GLOS·AIR
LIMITED

GLOS AIR SERVICE BULLETIN No. I

VICTA IOO & II5 Spinners

TRANSMITTER PT. No 48204/2

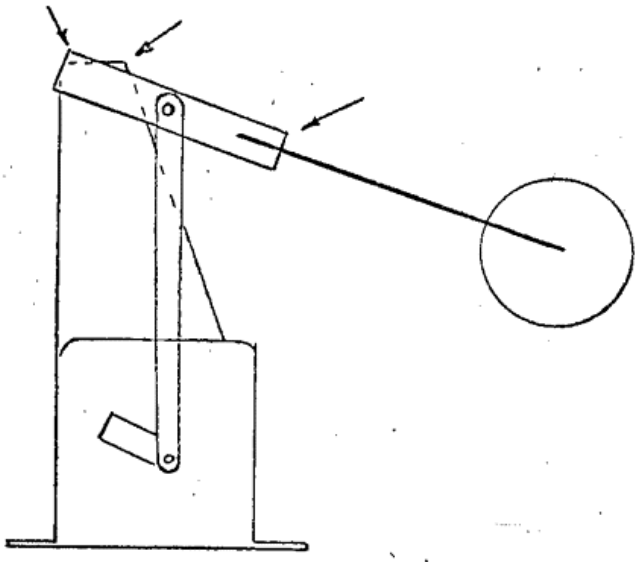
These have been caused by the top of the fuel contents transmitter chafing against the fuel tank (see attached drawing).

2. Inspect fuel tank for evidence of chafing immediately above the transmitter Pt No 48204/2. If any evidence of contact or wear is apparent remove the tank and repair in accordance with Victa Service Letter No 65/2.

3. Round off sharp corners on the fuel tank transmitter as per attached drawing and ensure that there is a minimum of ¼ inch clearance between the top of the transmitter and the fuel tank when the transmitter is installed and the float is at its highest position.

REMOVE SHARP CORNERS AS INDICATED BY ARROWS

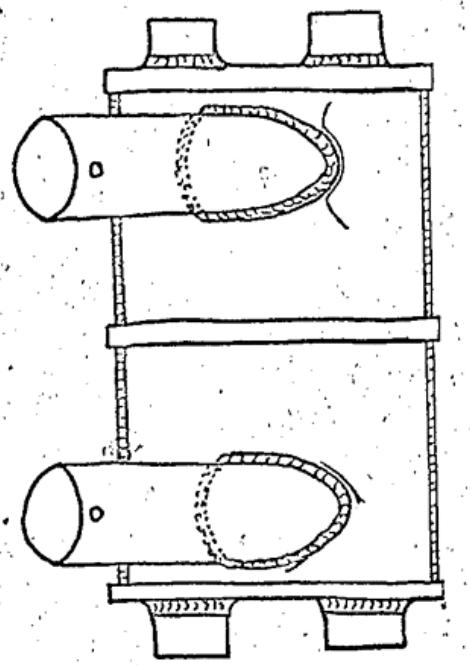
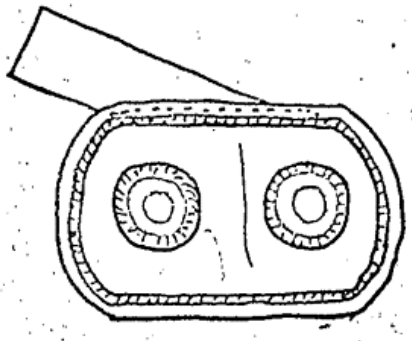
1. Recent routine inspections have revealed cracks in the exhaust heater muff assembly Pt No 42339/2 - See Page 2 for location of cracks. This could possibly introduce Carbon Monoxide into the cabin heating system.
2. Within 5 hours flying time remove the outer casing from the muff assembly and inspect for cracks paying particular attention to the welded joints.
   Cracked assemblies should be replaced.
3. This inspection must be repeated every 100 hours elapsed flying time.
4. At 12 month intervals the assembly must be pressure tested to 1½ p.s.i. to check for leaks.
5. The attention of owners and operators is drawn to ARB Notice No 40.
6. The inspections required by this Bulletin have been made Mandatory by the Air Registration Board.

| HEAT TREATMENT | TREATMENT | when one part only | LATROBE VALLEY AERO CLUB | ELECTRIC FUEL PUMP HEAT DEFLECTOR | L.V.A.C. 111 |

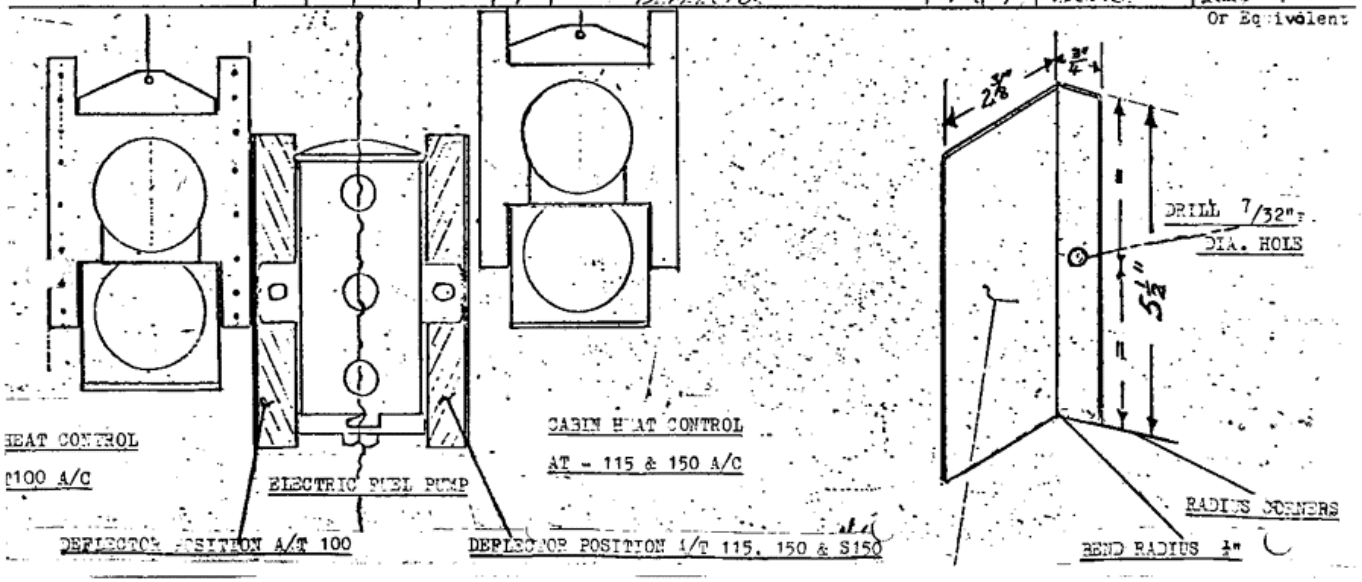
Details: It has been reported that suspected cases of fuel vapourisation has occurred in Australia caused by the electric fuel pump being overheated by the exhaust of hot air from the cabin heater distribution box assembly.

Rectification: Install a deflector plate in accordance with Drawing on Page 2 to ensure that the exhaust of hot air from the cabin heater box assembly is deflected away from the electric fuel pump when the cabin heater is selected to the off position. Fitting of above Deflector plate satisfies the requirements of Australian Airworthiness Directive DCA/VAT/36

Wiring Diagram fo[illegible] [illegible]lation of Flasher Unit in all Airtourer Aircraft to Provide Stall Warning Light in the Flap Up Position When Horn is Isolated.

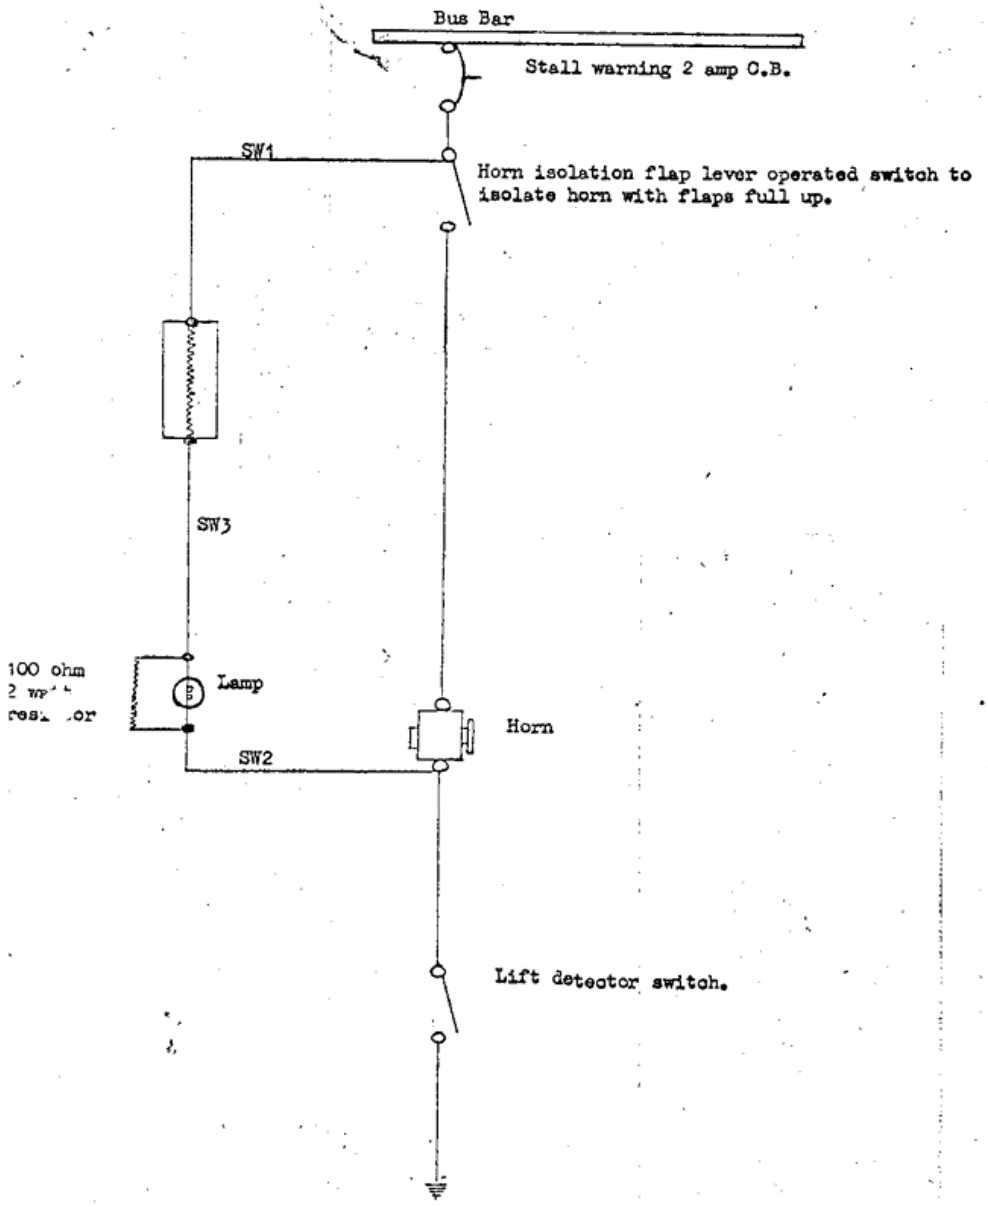
Subject — Installation of light and flasher unit to provide stall warning when flaps are up and horn is isolated.

6. Re-fit short link between micro-switch and horn. (Note: Check wiring diagram on Page 3 to ensure micro-switch is wired correct way round.)

VIEW FROM AIRCRAFT CENTRE LINE LOOKING OUTBOARD PORT
AT APPROX STN 104 AND BELOW LUGGAGE BAY

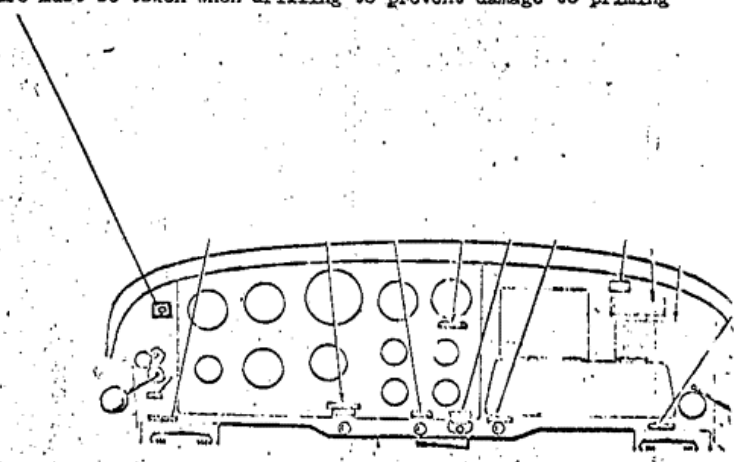
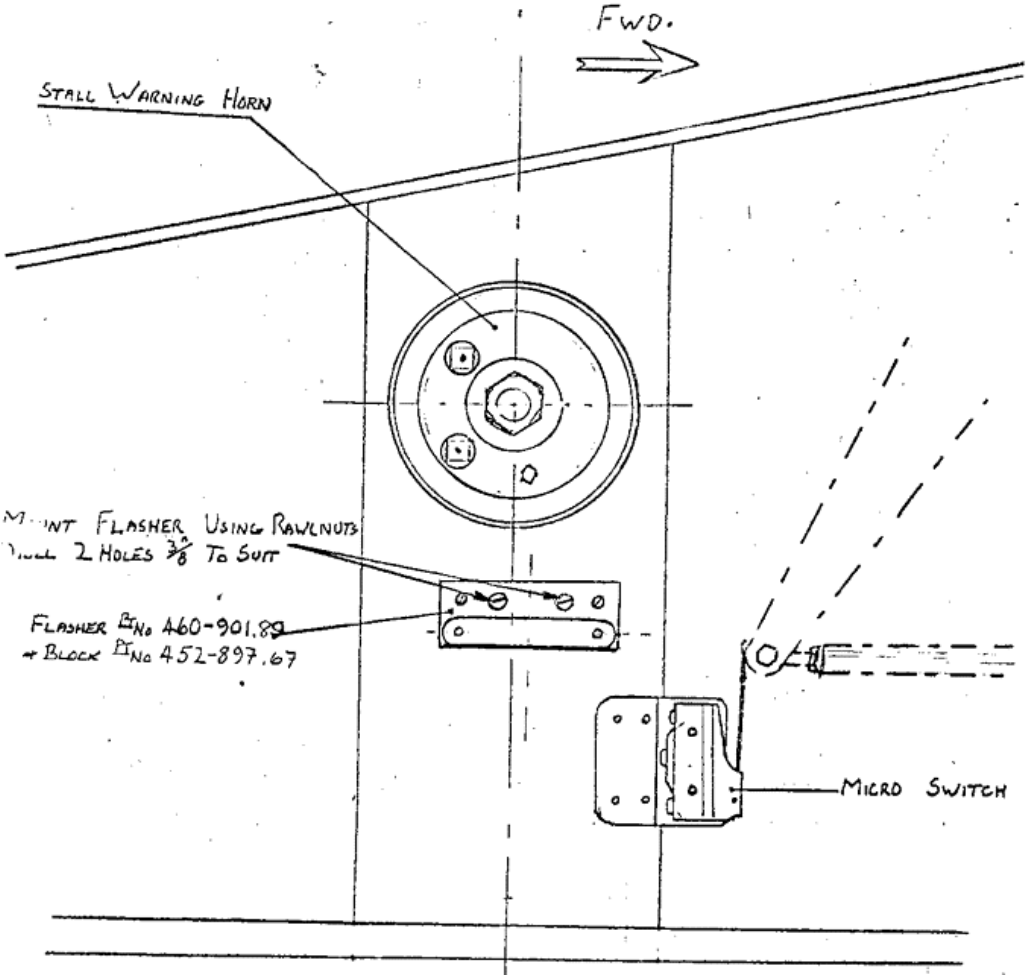
Mark off and drill ½" hole in fixed instrument panel as close as possible to the A.S.I. but not so high that it prevents it from being visible to the pilot.

Note: Care must be taken when drilling to prevent damage to priming lines.
